Subject: Williams Bay – Women’s Leadership Center Site Plan Approval Recommendation

The planning commission tabled both the conditional use and the final site plan approval request of the Women's Leadership Center (WLC) until the engineering and legal issues were resolved. This was following a presentation by the WLC professionals. The engineering issues relate to the final site plan; we are seeking input from committees because the issues may impact future Village budgets and public facilities around the WLC development. The most recent site plan submittal was received on November 1, 2023; we are still reviewing it.

To: Plan Commission – Village of Williams Bay
From: Attorney Mark A. Schroeder
Date: November 6, 2023
Re: Constance Woods LLC Development Proposal

1. Sheet C-500 (Grading & Erosion Control Plan): We normally do not allow new structures in the 100-year overland flow route. Please show the following to confirm the new structures will not cause onsite or offsite issues:

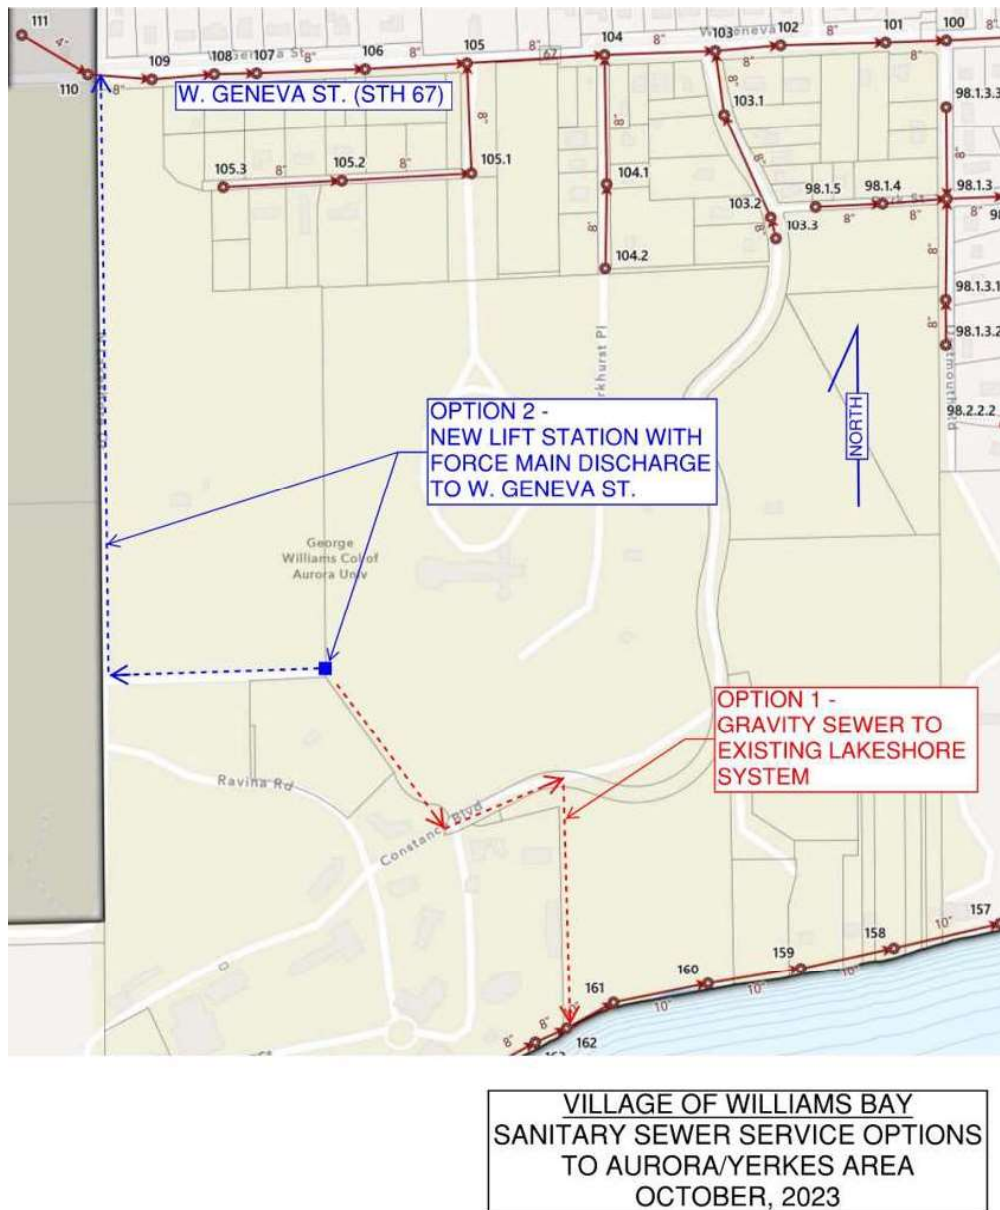
Water Main: See reference 1 and 2 on the attached site plan. There is an existing 6-inch water main and easement traversing the property within the footprint of the proposed building and parking lots. The plan is to abandon the water main and vacate the water main easement and allow a new 8-inch water main within a 20-foot-wide easement as a replacement. The new route would follow the private roadways and make a connection to the right of way of Constance Boulevard. We would recommend approval of this portion of the site plan and need committee concurrence.

Sanitary Sewer Paralleling the Lakefront: See Reference 3 on the attached site plan. There is an existing 10-inch gravity sanitary sewer that extends from Lift Station 5 in Conference Point that is within a 10-foot easement. This sewer was televised shortly after the WLC project began; the televising found significant grease, debris, and clear water inflow. This downstream sewer needs cleaning and repair to provide adequate service to WLC and George Williams. WLC has refused to participate in the funding of this repair, even though they are a new connection to the sewer. They appear willing to vacate the existing 10-foot-wide sanitary sewer and provide a 20-foot-wide replacement easement. We recommend approval of this portion of the plan if the Village commits to the sewer cleaning and repair prior to occupancy. We need input from committees on how to proceed with this issue.

Existing Drainage and Future Reconstruction of Constance Boulevard: See Reference 4 and 5 on the attached site plan.

- Regarding Reference 4: WLC is proposing to locate a dock and boardwalk in an existing drainage ravine that drains Constance Boulevard and areas upstream. We are requiring that they provide the proper hydraulic calculations to show the 100-year flood boundary on their property with the proposed structures and the existing trees. We recommend a storm sewer easement that includes this 100-year flood boundary. This will allow the Village to reconstruct Constance Boulevard without claims and prevent future owners from adding more structures to the flood boundary. WLC is resisting this; we need input from committees on how to proceed with this issue.

providing an easement to WE Energies for a gas main at this same location. There are also existing fiber optic cables at this location. Unless WLC is willing to dedicate the area, the Village will likely need to purchase it as part of the roadway reconstruction to correct a potential safety issue and to improve drainage on Constance Boulevard. We need input from committee on how to proceed with this issue.

Sanitary Sewer Easement – West Property Line: See Reference 6 on the attached site plan and the snip below.

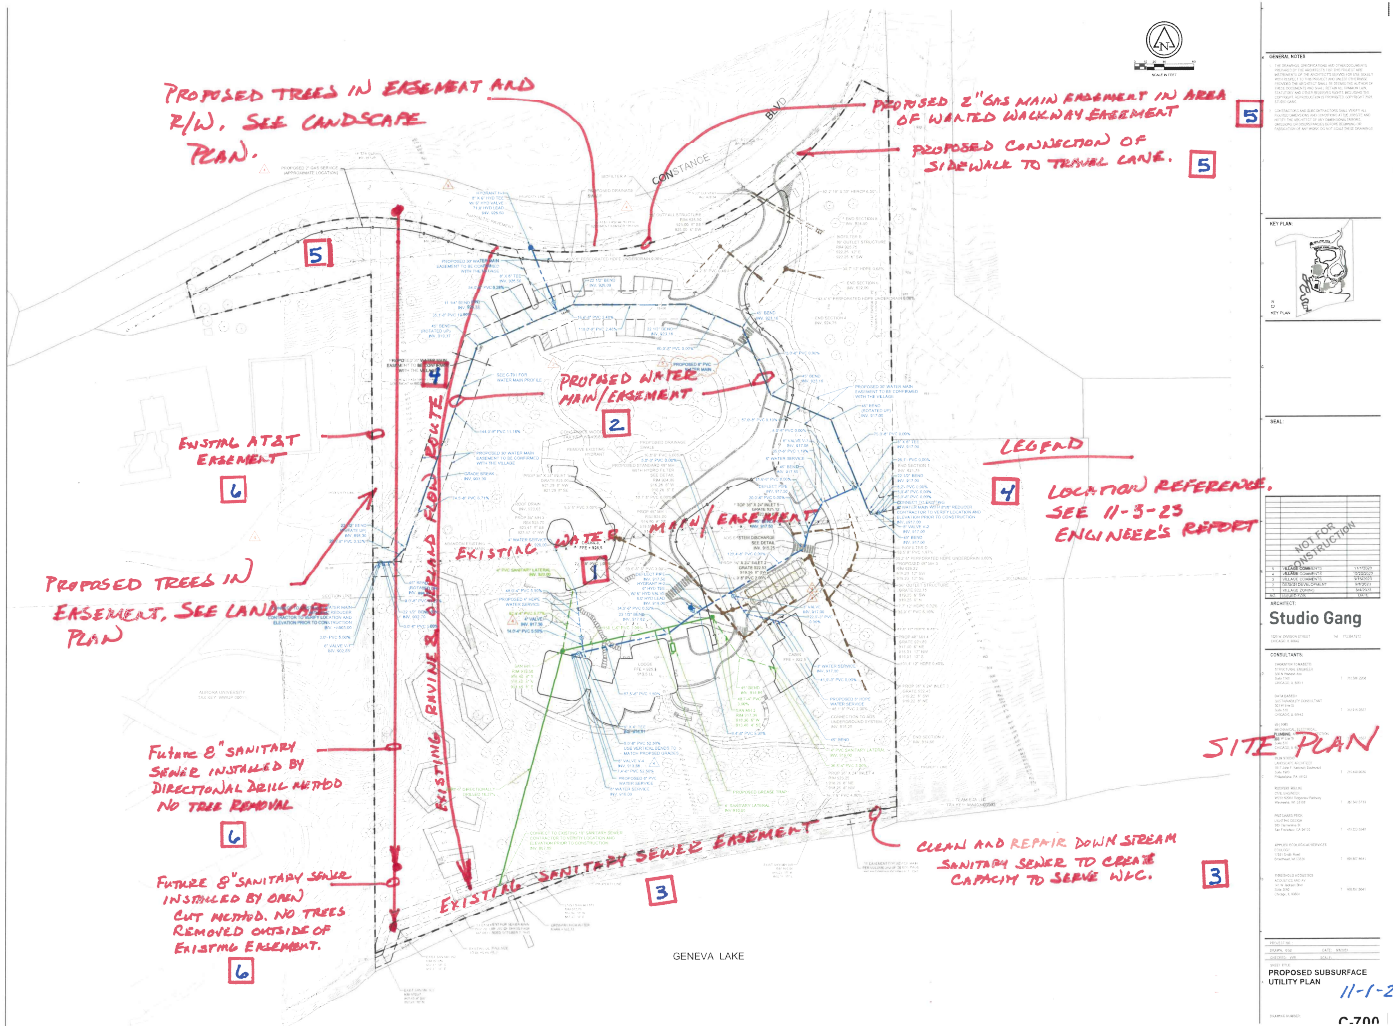
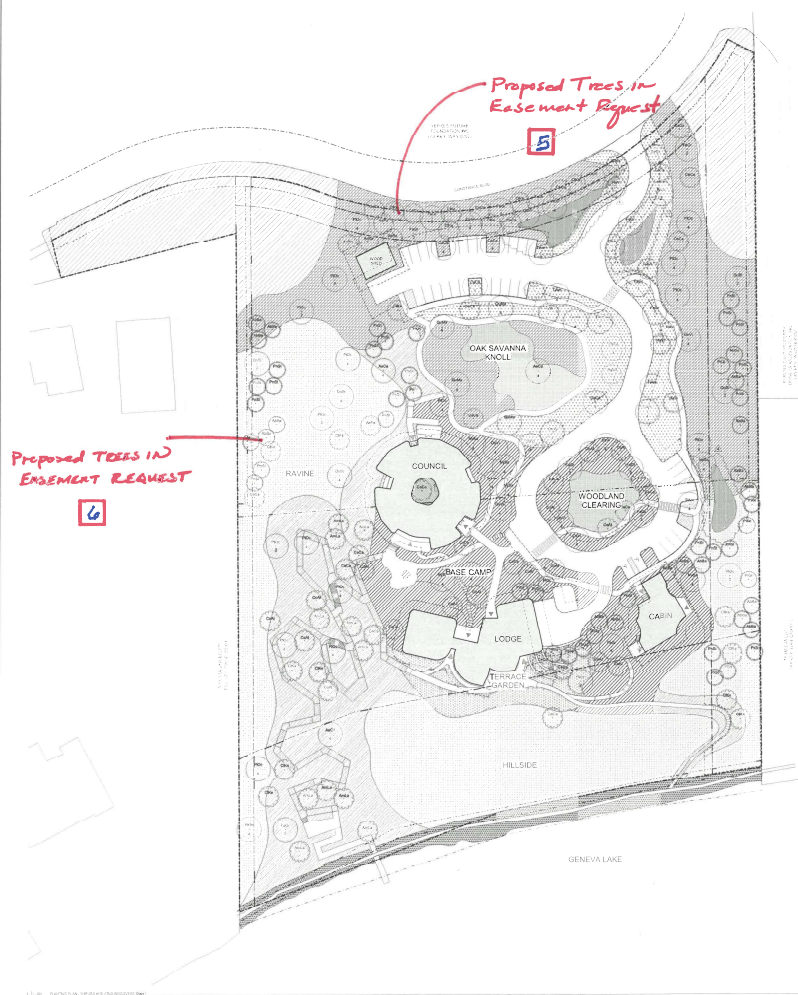
- This proposed 20-ft minimum exclusive easement for sanitary sewer near the west property line may prevent the Village from spending an additional \$2 million for a sewage lift station and force main connection to W. Geneva Street to provide sanitary sewer service to the areas north and west of this property.
- The Village can vacate this requested easement in the future if they decide to leave this area unsewered or find alternate means of providing sanitary sewer service to the area upstream.
- It is unlikely that the requested easement can be obtained by eminent domain in the future since there is another option available.

1. Vacate the existing water main easement, as proposed on site plan.
2. Provide exclusive water main easement as proposed on site plan.
3. Vacate the existing sanitary sewer easement on lakeshore, as proposed on site plan.

4. Provide 20-ft minimum exclusive easement for lakeshore sanitary sewer, as proposed on site plan.
5. Provide drainage easement over land including 100-year flood boundary, as determined by the Village Engineer. Developer agrees to provide an as-built survey of the new structures and existing trees placed in the drainage easement.

6. Provide easement or right-of-way on the south side of Constance Blvd. for separated pedestrian path and drainage. This is the same area as the existing fiber optic and same area proposed for the WE Energies gas main and easement. As an alternate, make provision for the Village to purchase it for a nominal sum without eminent domain at the time of reconstruction of Constance Boulevard.

7. Provide a 20-ft minimum exclusive easement near the west property line for future sanitary sewer to serve the area north and west of Constance Boulevard. The Village will vacate this easement if an alternate route is provided for sewer service in the future. As an alternate, make provision for the Village to purchase it for a nominal amount in the future without eminent domain.

CROSS SECTION B-B
HORZ 1" = 2.5'; VERT 1" = 0.25'

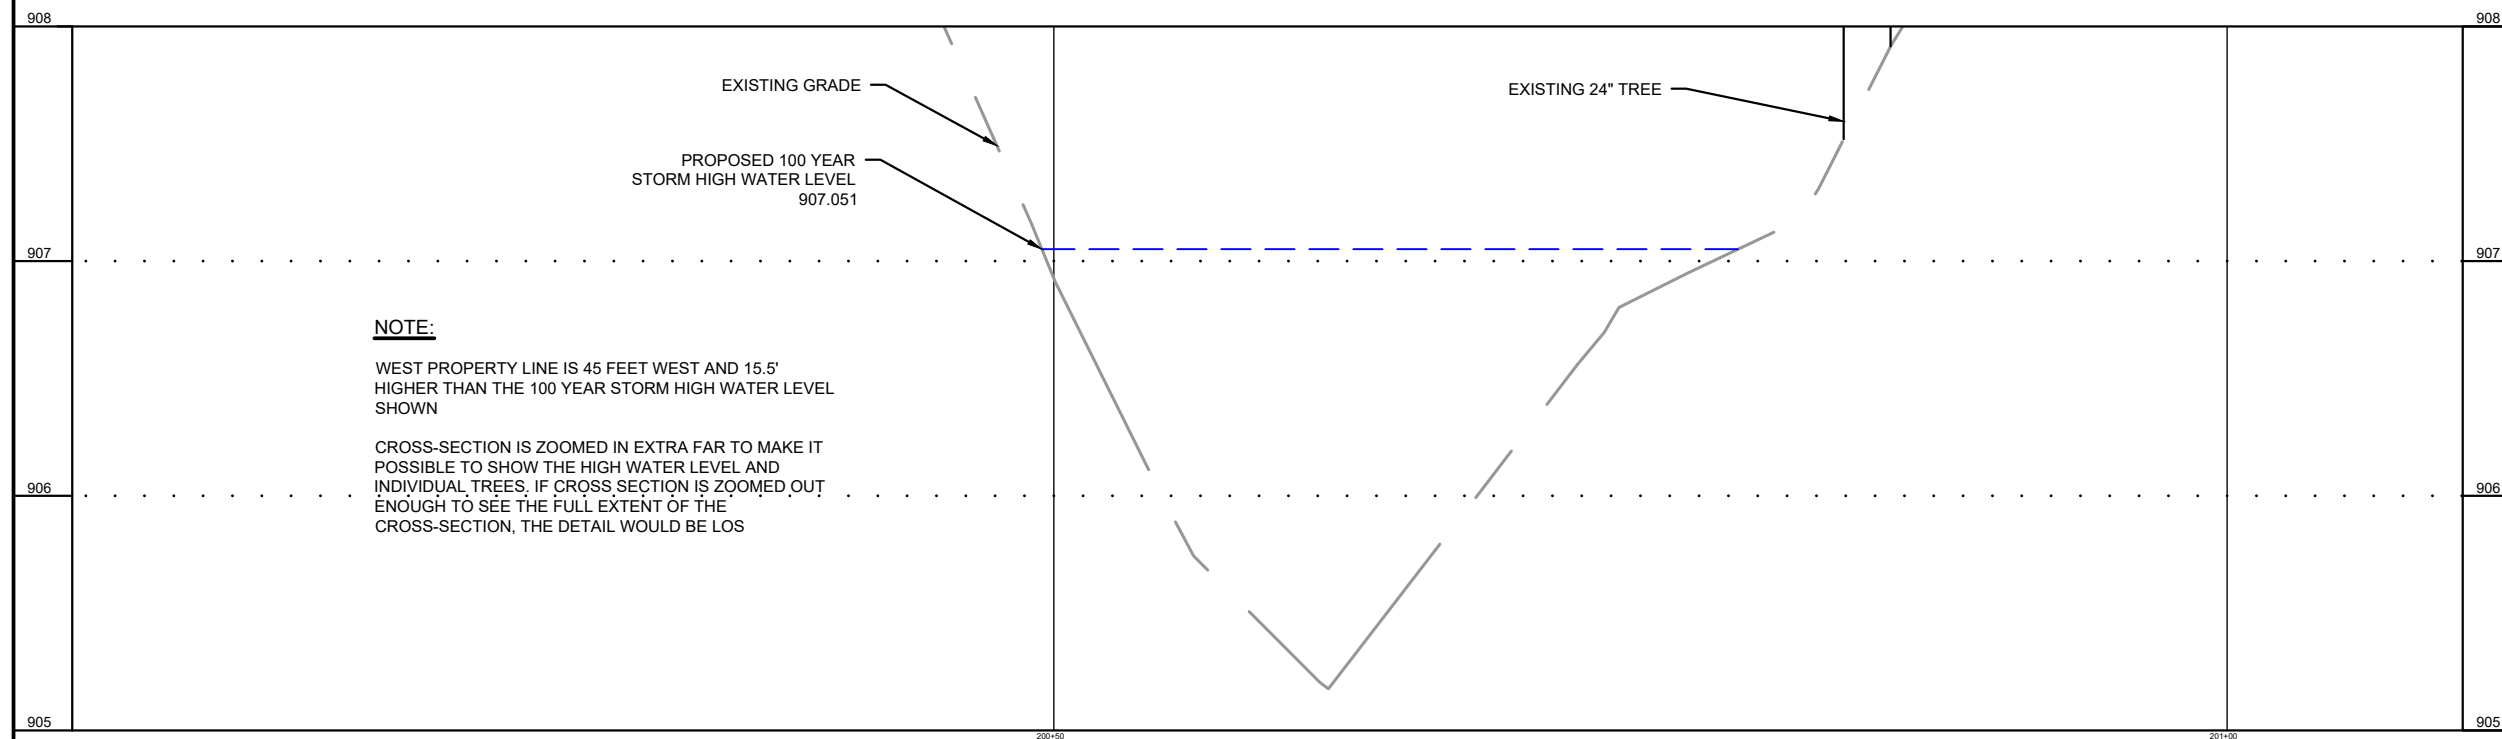
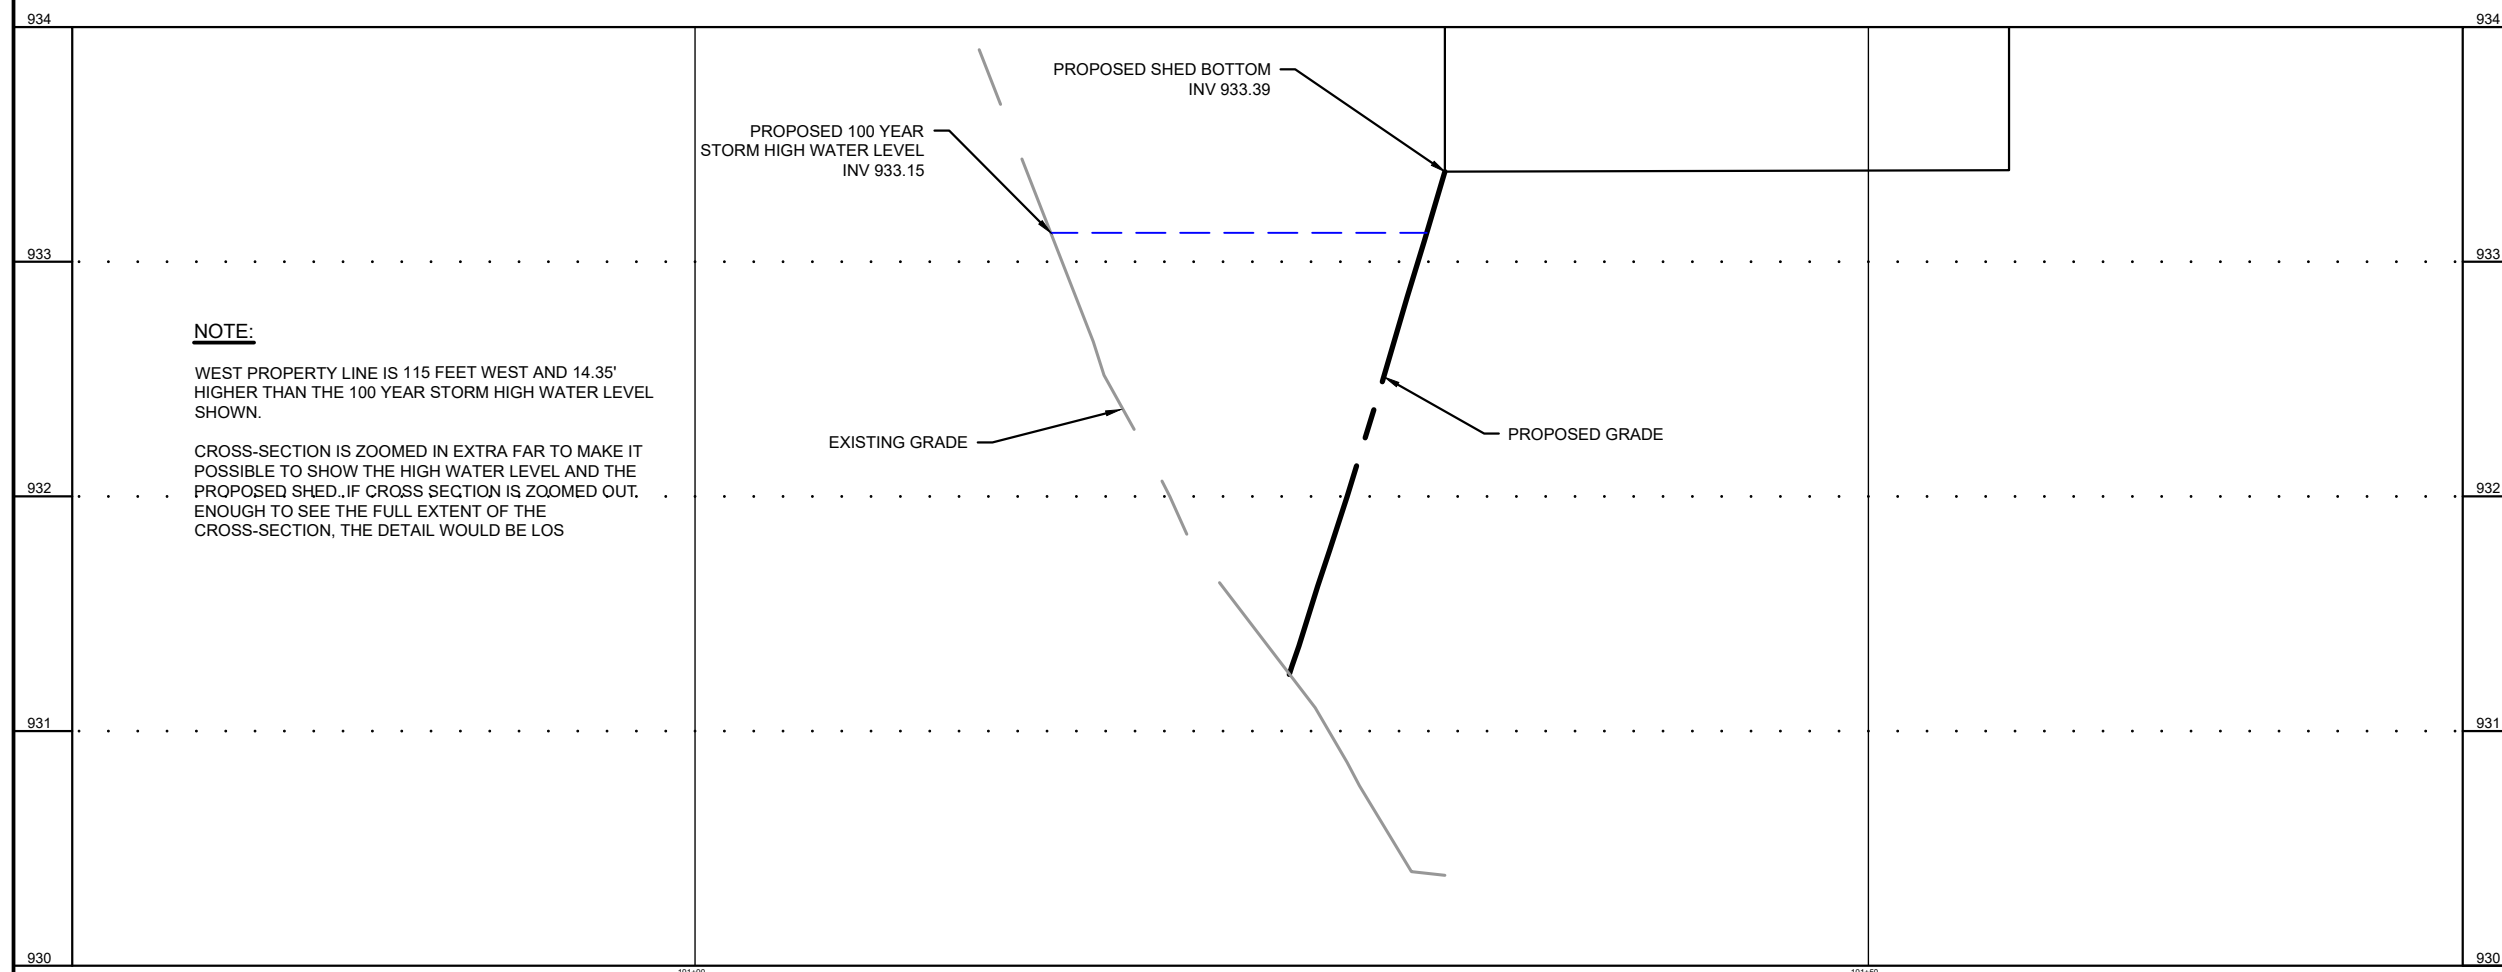
- a. Tie the location of the analyzed cross-sections to the property lines. They are not shown on Exhibit 2 as noted in the response letter.

Exhibit 2 (pg. 15 of the SWMR and included with this letter) has been updated to show the four analyzed cross-sections (A-A, B-B, C-C and D-D).

Sheets added to Appendix E (pgs. 225-229) and included in this letter to show the four cross-sections referenced in Exhibit 2 with existing trees and proposed boardwalk pilings. The 100-year overland flow boundary was also drawn and added to Exhibit 2. The n-value of the cross-section model is approximately double what it should be ($n=0.15$ is equivalent to dense brush with many downed trees). This provides an extremely conservative estimate and that is what is shown in Appendix E and Exhibit 2. Please note, the scaling on the cross-section views are very different in the model versus the sheets added to Appendix E with the trees and boardwalk shown.
